Working Errata for SegMan
03/25/2019
Hayden Dodge

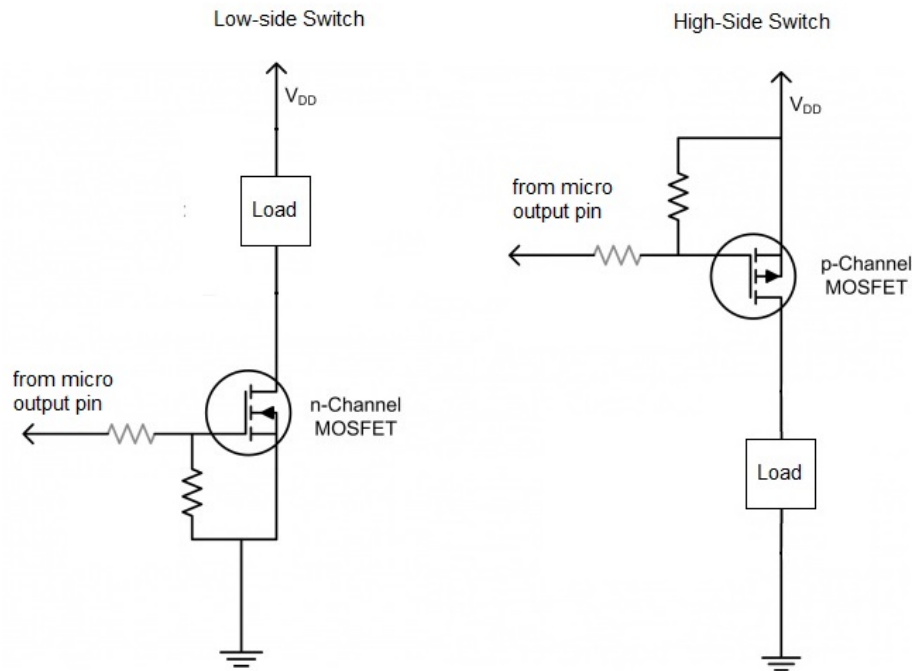
1. Q1 is an N-channel Mosfet and it is currently configure as a high side switch. This will not work. Configure this a low side switch to drive the Charge Relay.

2. The charge circuit needs to be fused. Add 20 A fusing for J8 on both Chrg+ and Chrg-.
3. There is no way for PackMan to know when the Charger is plugged into the ChargePort. See prior PackMan Charge port detection implementation.
 - a. Detect shorted jumper in charger from extra pins in charge port.
 - b. Be able to control the Charge Relay K1 from the Pack User interface.
4. Add version/revision number to schematic. Add date to schematic.
5. Size schematic to fit US Letter size paper. This will make it print better.
